TRANS/WP.29/2005/84  
28 July 2005

PROPOSAL FOR CORRIGENDUM 3 TO THE 06 SERIES OF AMENDMENTS  
TO REGULATION No. 14

(Safety-belt anchorages)

Transmitted by Working Party on Passive Safety (GRSP)

Figure 7: ISOFIX Top tether anchorage location, ISOFIX zone - Enlarged side view of wrap-around area "

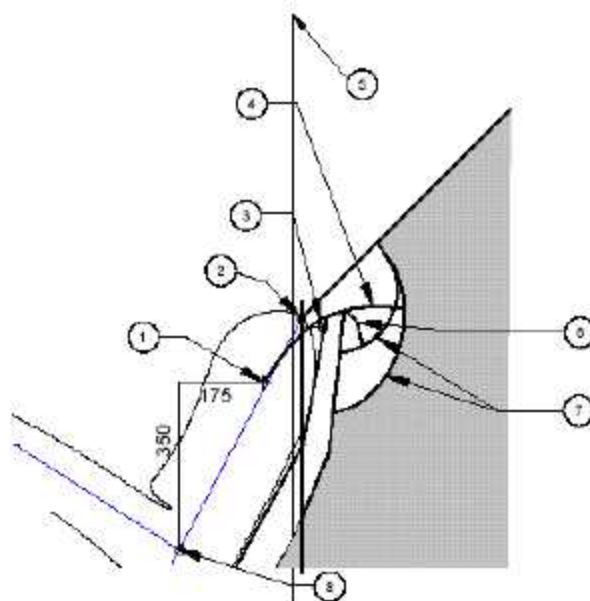
Annex 9, Figure 7, amend to read:

- 1 "V" point
- 2 "R" point
- 3 "W" point
- 4 Strap wrap-around length from "V" point: 250 mm
- 5 Vertical longitudinal plane
- 6 Strap wrap-around length from "W" point: 200 mm
- 7 Arcs created by wrap-around lengths
- 8 H-point

- NOTE 1 Portion of top tether anchorage that is designed to bind with the top tether hook to be located within shaded zone
- NOTE 2 "R" point: Shoulder reference point
- NOTE 3 "V" point: V-reference point, 350 mm vertically above and 175 mm horizontally back from H-point
- NOTE 4 "W" point: W-reference point, 50 mm vertically below and 50 mm horizontally back from "R" point
- NOTE 5 "M" plane: M-reference plane, 1000 mm horizontally back from "R" point
- NOTE 6 The forwardmost surfaces of the zone are generated by sweeping the two wraparound lines throughout their extended range in the front part of the zone. The wraparound lines represent the minimum adjusted length of typical top tether straps extending from either the top of the CRS (W-point), or lower on the back of the CRS (V-point).
